LUAS FINGLAS

EMERGING PREFERRED ROUTE

SUBMISSION
September 2020

**DUBLIN
COMMUTER
COALITION**

Figure 2: Proposed BusConnects network in the Charlestown area

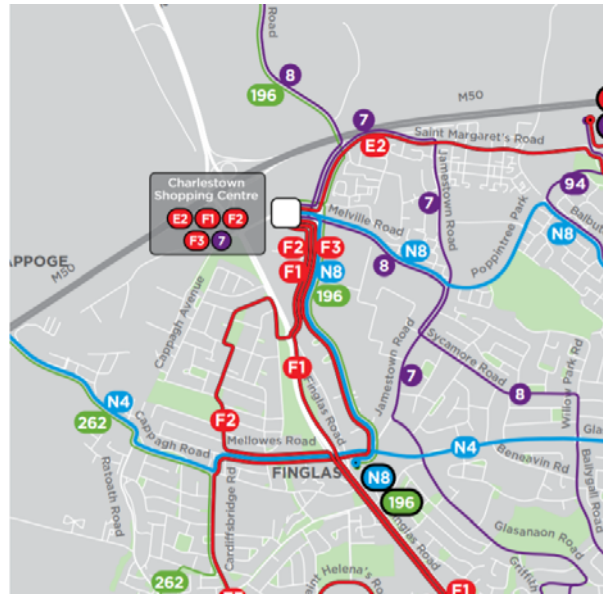
While we recognise that the proposed frequencies and journey times are preliminary, the proposed frequency of 8 trams per hour per direction would be the lowest of any terminus on the Luas system. It has not been made clear if this is an operational choice or a design limit. Public transport

users in the Charlestown area would be accustomed to frequencies as high as 27 buses per hour (E2, F1, F2, F3 and 7) into the City Centre at peak times under the proposed BusConnects network. While they would benefit from the additional capacity of Luas, if the proposed Luas frequency is any lower at off-peak times then they would lose some of the freedom offered by the proposed high frequency BusConnects network.

Figure 3: Locations of pedestrian crossings in Finglas village which would improve connectivity to the proposed Luas stop

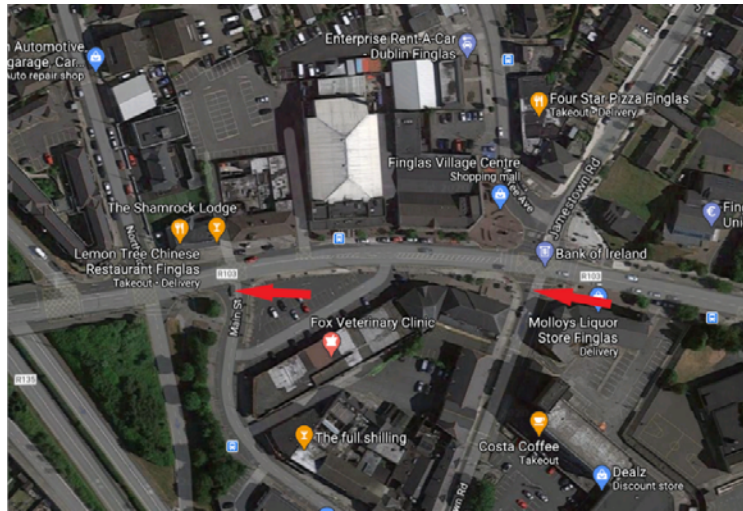
The proposed Finglas Village stop has a very large catchment area stretching from Finglas East to Finglas West and Finglas South. To enable passengers to walk from this stop to the village centre and nearby areas, it is imperative that safe walking routes are provided. This would require modifications to footpaths and junctions in Finglas village such as:

Pedestrian crossings must be provided across the busy junctions on Seamus Ennis Road with Jamestown Road and Main Street. Due to a lack of safe crossing point across Jamestown Road, a journey from Jamestown Social to the proposed Luas stop 400m away would involve nine pedestrian crossings (six signalised and three non-signalised). This 400m journey could easily take ten minutes. This poor existing standard of connectivity would negatively impact access from Finglas village and Ballygall Road to the Finglas Village stop. Furthermore, the northern end of the five-arm junction also needs to be completely redesigned to make it safe for vulnerable users.

Figure 6: Slipways and pedestrian islands at the Charlestown junction

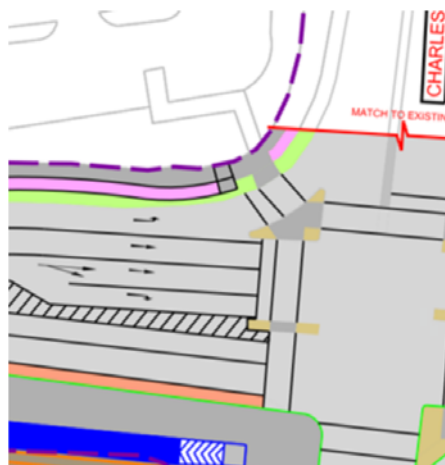
The EPR proposes retaining slipways and multistage crossings at the junction outside Charlestown Shopping Centre. This car-centric design is

unsuitable given the large number of pedestrians that will travel between the Luas stop and the shopping centre. It's also unsuitable for the hundreds of pedestrians that will cross between the park & ride and the Luas stop at peak times. The pedestrian islands and waiting areas are not safe to handle the surge of pedestrians. This junction must be redesigned for people, not cars.

Figure 7: BusConnects preferred route drawing of the Finglas Road junction

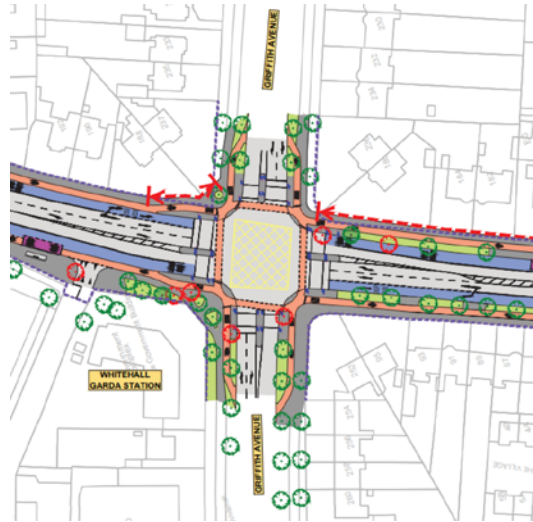
The redesign of the Finglas Road and St. Margaret's Road roundabout presents an excellent opportunity to finally make this junction safe for pedestrians and cyclists. However, the proposed design is overbearing and hostile for vulnerable road users. It feels like a missed opportunity that emphasises traffic flow over access to the Luas stop itself. At the very least, one of the northbound lanes on the Finglas Road should be removed to tie in with the BusConnects preferred route for the Finglas Road which proposes one bus lane and one general traffic lane only.

We strongly urge TII to consult with the NTA design teams that are currently working on junction designs for BusConnects Core Bus Corridors. Below is an example of a protected junction from BusConnects Core Bus Corridors.

Figure 7: BusConnects preferred route drawing of the Finglas Road junction

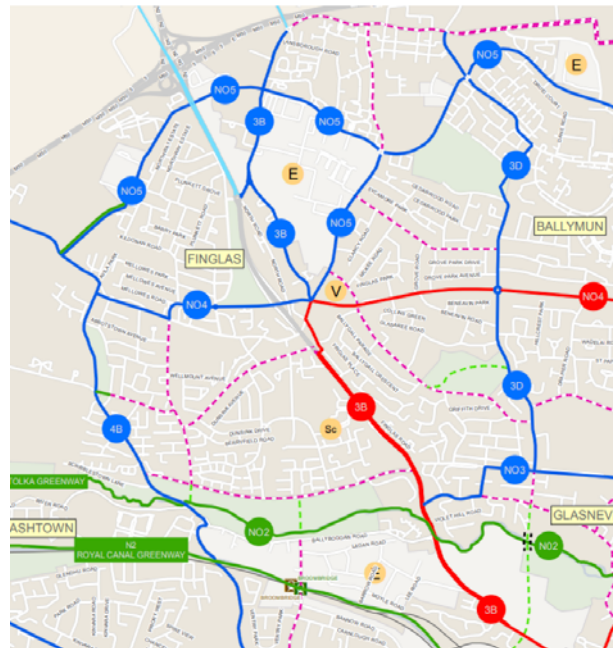
For example, a parallel cycling route should be provided between Broombridge and Tolka Valley Road. There is ample space within the industrial estate to provide this. At Patrickswell Place, the cycling route suddenly changes to unsegregated on-road cycle lanes. Given the low

number of entrances onto the road, this section would be greatly improved by continuing the two-way cycle tracks.

The NTA's Greater Dublin Area Cycle Network Plan outlines proposed and existing cycle routes and greenways in the Greater Dublin Area. By ensuring the proposed route connects with the local cycle network as well as the Tolka Valley and Royal Canal Greenways, a safe and continuous network can be delivered in Broombridge and Finglas.

Figure 7: BusConnects preferred route drawing of the Finglas Road junction

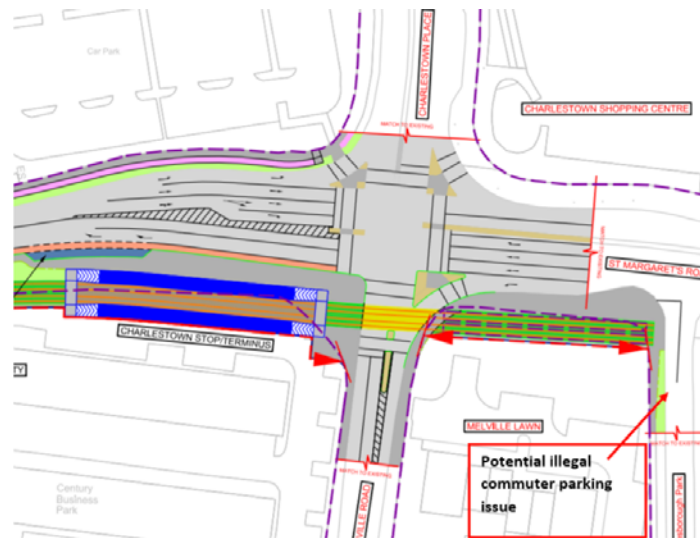
The convenience of access to Lanesborough Park compared to the park & ride for motorists travelling south on St. Margaret's Road – especially at peak times – poses a risk of Lanesborough Park and nearby residential areas being used for commuter parking. This area already suffers from illegal parking by motorists visiting Charlestown Shopping Centre despite free parking being provided beneath the shopping centre and the very same surface car park that is proposed to be used as the park & ride for this project.

Without appropriate measures, this may aggravate the issue. Filtered permeability at the junction with St. Margaret's Road and Lanesborough Park is a potential solution. It's already not possible for vehicles to turn right from Lanesborough Park onto St. Margaret's Road or right from St. Margaret's Road onto Lanesborough Park. This may require consultation with residents to arrive at a workable solution.
